# Groundwater Application Review Summary Form

Application # G- 18825

TO: Water Rights Section Date 1/23/2020  
 FROM: Groundwater Section Ben Scandella, Justin Iverson  
 SUBJECT: Application G-18823 Supersedes review of \_\_\_\_\_  
 Reviewer's Name  
 Date of Review(s)

**A. GENERAL INFORMATION:** Applicant's Name: DOANN HAMILTON; PACIFIC HYDRO-GEOLOGY INC.  
 County: TILLAMOOK

### Water-Level Trends in Nearby Wells

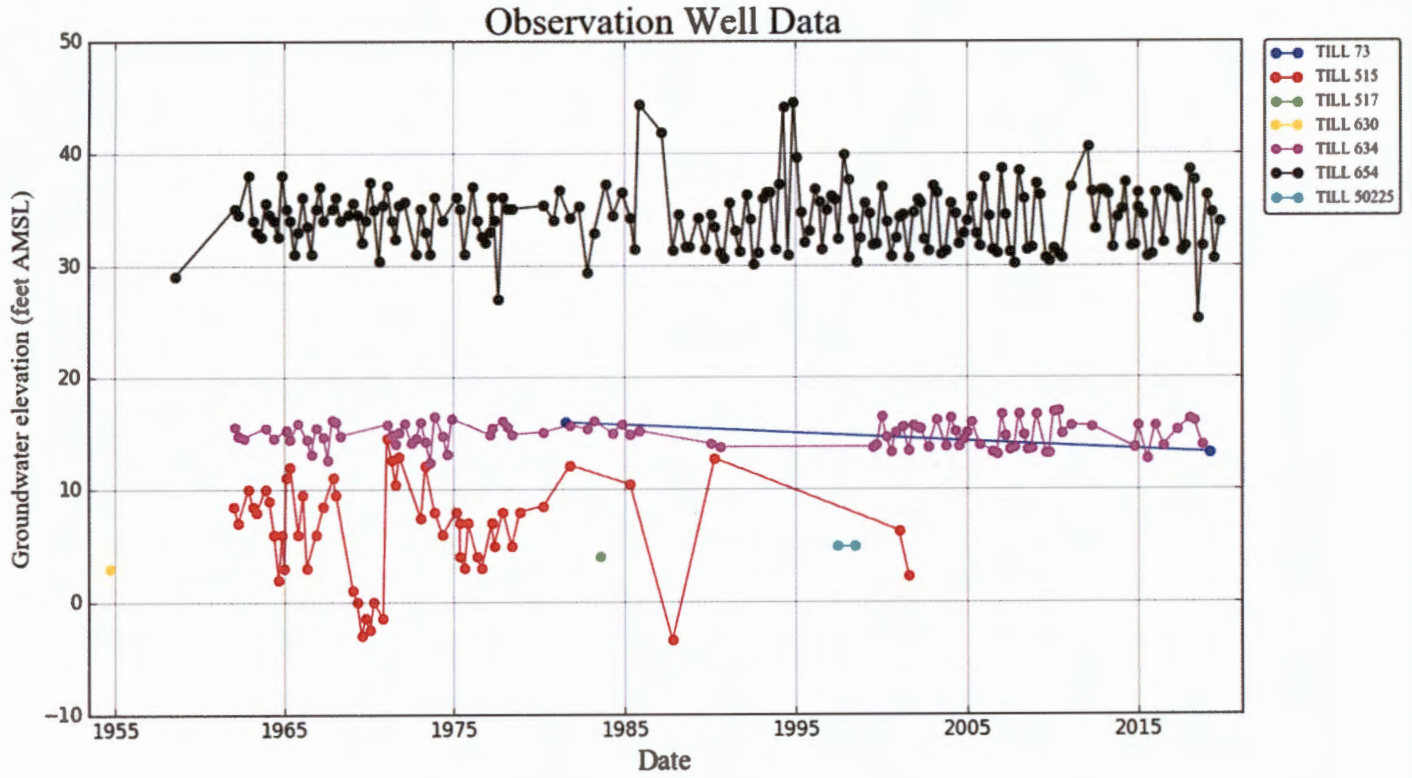
Three observation wells are in the area: TILL 515, 634, and 654. Seasonal water level fluctuations range from less than 5 foot at the westernmost well (TILL 634) to over 10 feet at TILL 515, approximately 2 miles east of the subject well. The TILL 515 hydrograph appears to contain pumping data, so the exact seasonal fluctuation is difficult to ascertain.

Stream depletion modeling parameters and results

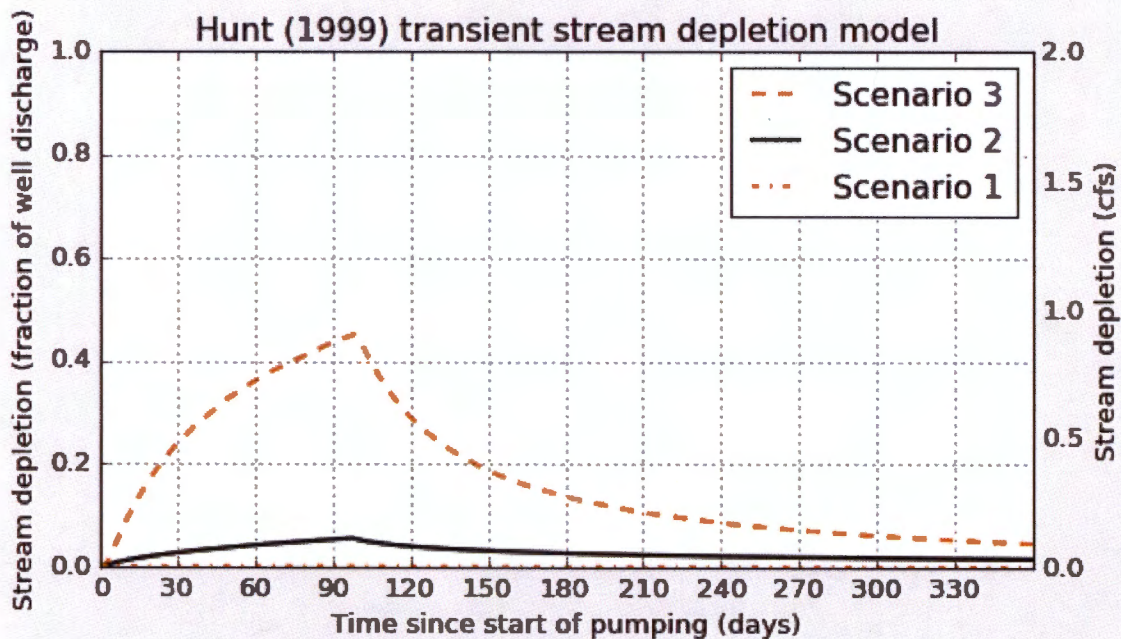
**Basis for impact evaluation:** The combination of Well 2 (Applicant's proposed Well 3) and Stream 2 (Trask Slough) is expected to experience the greatest potential depletion due to their proximity. This combination was modeled using the Hunt 1999 stream depletion model (Hunt, 1999), assuming constant pumping at the maximum rate from Well 2 until the total annual volume of 645 acre-feet was reached, after 101 days. Representative parameter values were estimated using the well logs for TILL 50225 and 50400, as well as standard literature (Freeze and Cherry, 1979). The most likely parameter values suggest that stream depletion at 30 days will be limited to 3% of the pumping rate, and even a highly conservative parameter set suggested it would be limited to less than 25% (see detailed results below).
